36 West 66<sup>th</sup> Street  
New York, NY

Peer Review Report  
Phase I (Foundation) V.4

Rosenwasser/Grossman Consulting  
Engineers, P.C.

June 22, 2018

**Figure 4.3.1 Maximum Bearing Pressure under (Dead + Live) loads**

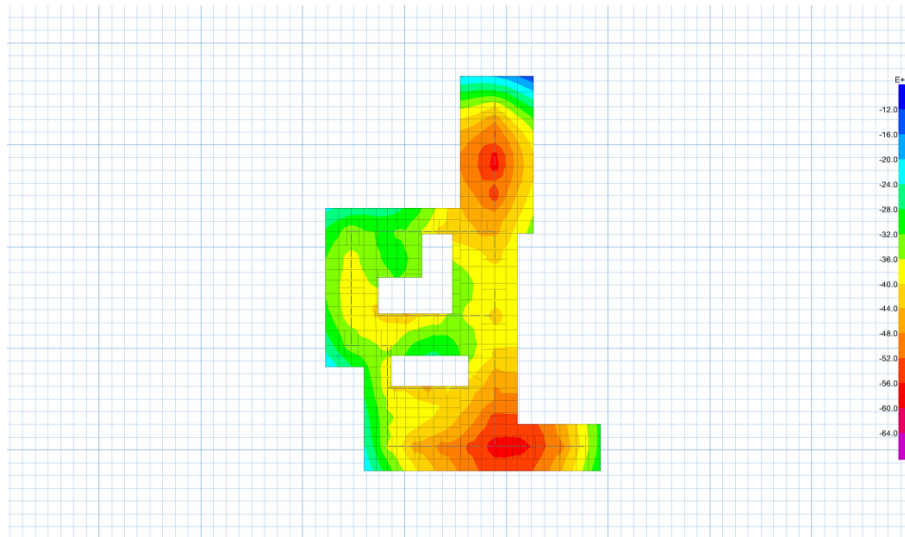
The loads from our ETABS independent model was exported to SAFE structural model in order to analyze the foundations. Our analysis indicates that the maximum bearing pressures under (Dead + Live) and (Dead + Wind) loads were acceptable within the allowable bearing pressures of 80 KSF. The bearing pressures are shown on the Figure 4.3.1 and 4.3.2 below.
